# RENESAS TECHNICAL UPDATE

Product Category	MPU/MCU		Document No.	TN-RX*-A020A/E	Rev.	1.00
Title	Precaution when Shifting to ROM-Read Modes		Information Category	Technical Notification		
Applicable Product	RX Family	Lot No.	Reference Document	Refer to the table below.		
		All lots

1) In section 26, ROM (Flash Memory for Code Storage) of the RX610 Group User's Manual: Hardware, the description of the register in section 26.2.8, Flash P/E Mode Entry Register (FENTRYR), has been revised.. The revision is indicated by the red letters below.

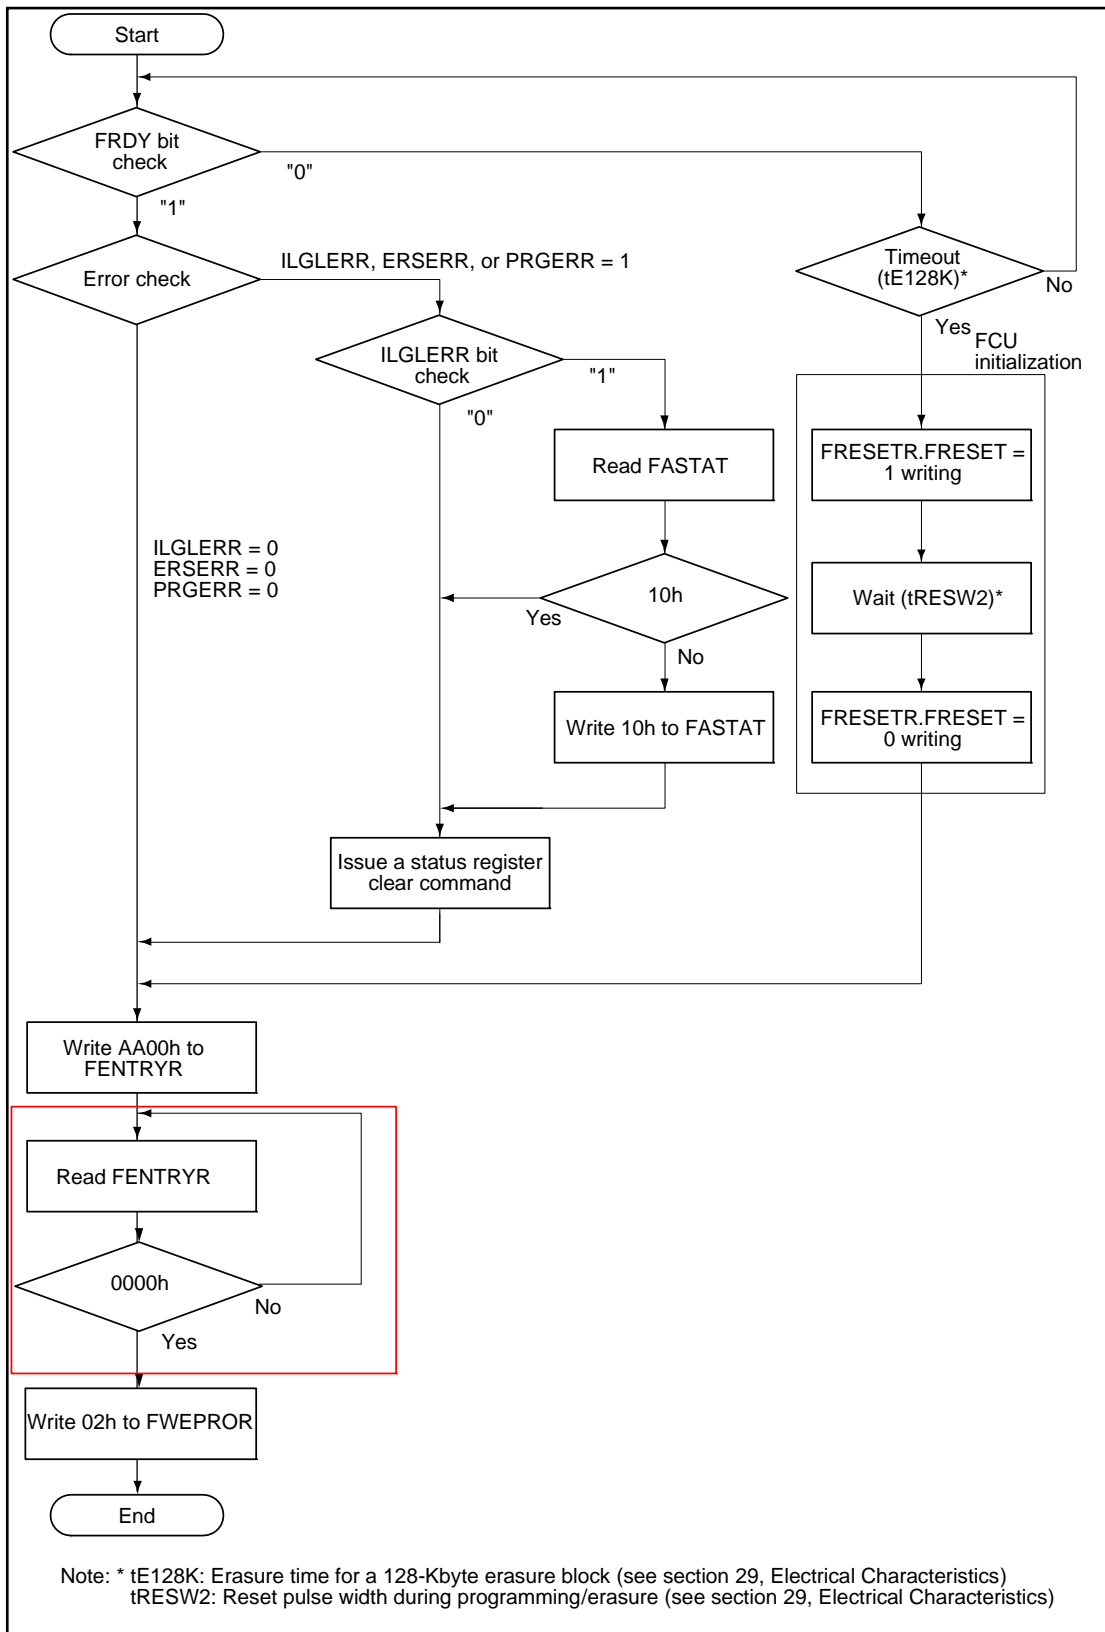
**After writing to FENTRYR to place the ROM or data-flash memory in ROM-read modes, read the register to check that the new value has actually been set. Only proceed with ROM-reading after that.**
